Land Use Petition: RZ-26-0001, SLUP-26-0002, CV-26-0001

PROJECT LOCATION:	4270 Lawrenceville Highway
APPLICATION NUMBER:	RZ-26-0001, SLUP-26-0002, CV-26-0001
DISTRICT/LANDLOT(S):	18 th District, Land Lot 214
ACREAGE:	± 21,921 sf/0.503 acres
EXISTING ZONING:	C-1 (Local Commercial), CZ-90028, RZ-19-0003
EXISTING LAND USE:	Vacant/former gift shop
FUTURE LAND USE MAP DESIGNATION:	Downtown
OVERLAY DISTRICT:	N/A
APPLICANT:	Julie Sellers/Dillard Sellers for Rocket Brew, Inc.
OWNER:	B&A Ventures, LLC
PROPOSED DEVELOPMENT:	SLUP to allow a drive-thru facility; concurrent variance to setback regulations; major modification request to amend conditions of zoning for RZ-19-0003
STAFF RECOMMENDATION:	Deferral of RZ-26-0001, SLUP-26-0002, CV-26-0001

Project Data and Background

Figure 1. Proposed northern elevation, including walk-up entry and mural facing Lynburn Drive.

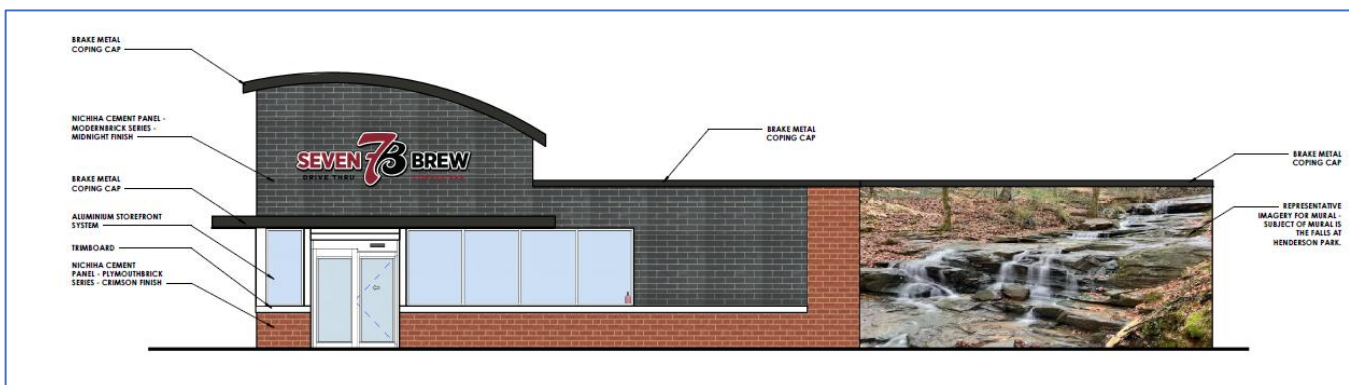
The drive-through canopy appears to be constructed of similar materials. However, staff recommends traditional brick sizes rather than the large modular blocks that are proposed, in order to be more compatible with the Downtown character area.

The requested concurrent side corner setback variance appears to meet the spirit and purpose of the Downtown character area of the comprehensive plan. The variance would bring the building closer to the street, which is an essential component of a pedestrian oriented downtown. Staff recommends that the developmental regulations of the DT special zoning districts be applied to this project to ensure compatibility with the regulations for the surrounding properties. For example, the use of standard sized brick rather than the proposed Nichiha panel brick, and the use of recesses and material changes to frame the proposed mural and create a more pedestrian orientated scale.

Fig. 2. June 10, 2019 Site Plan for RZ-19-0003 and SLUP-19-0006

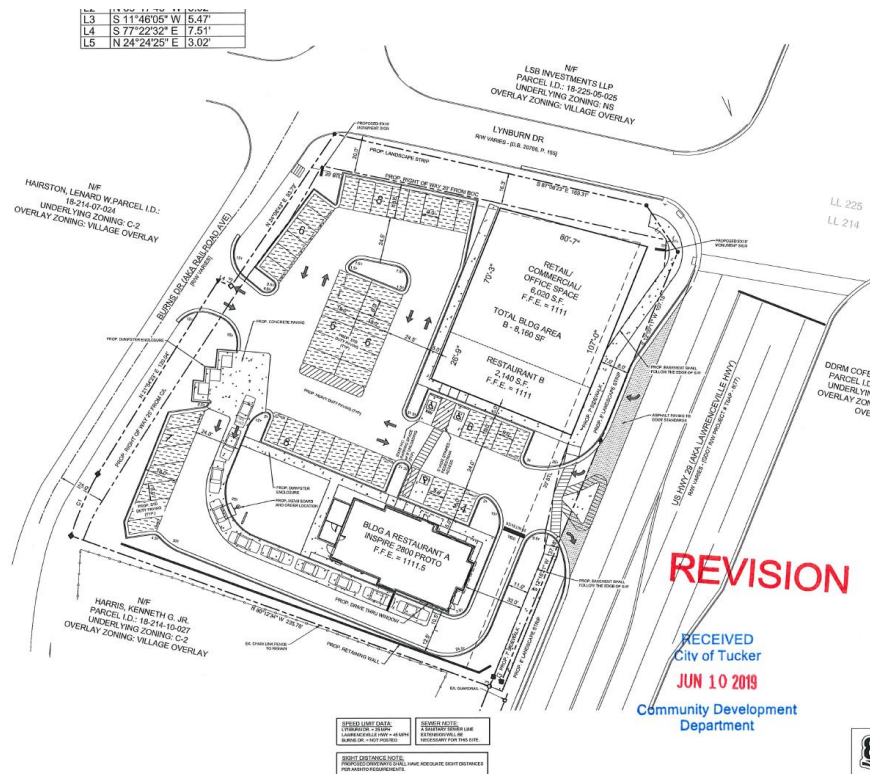
- The 2019 approval was conditioned to a site plan that included a retail/commercial/office building on the subject parcel at the corner of Lynburn Drive and Lawrenceville Highway. This building was required to have a prominent entry feature and building design that activated the corner, as well as an entrance oriented toward the intersection. The additional parcels at the time allowed the drive-through restaurant to be located away from the intersection and screened by mixed-use building. The site plan also allowed for more vegetation to screen the appearance of the drive-through lane from the street.

- In order to develop outside of the approved conditions and site plan (dated June 10, 2019), a major modification is required. Staff will note that these applications were submitted before the city-wide zoning initiative (RZ-19-0002) that rezoned all of the parcels in the Downtown Tucker Overlay District to the Downton Special Zoning Districts.

The applicant has stated that, due to changing ownership of the parcels included in the 2019 zoning approval, it is no longer possible to develop the June 10, 2019 site plan. Therefore, the applicant wishes to develop this single parcel under the C-1 zoning without the restriction of the prior land use cases. A modification is warranted, but the proposal should comply with the regulations herein.
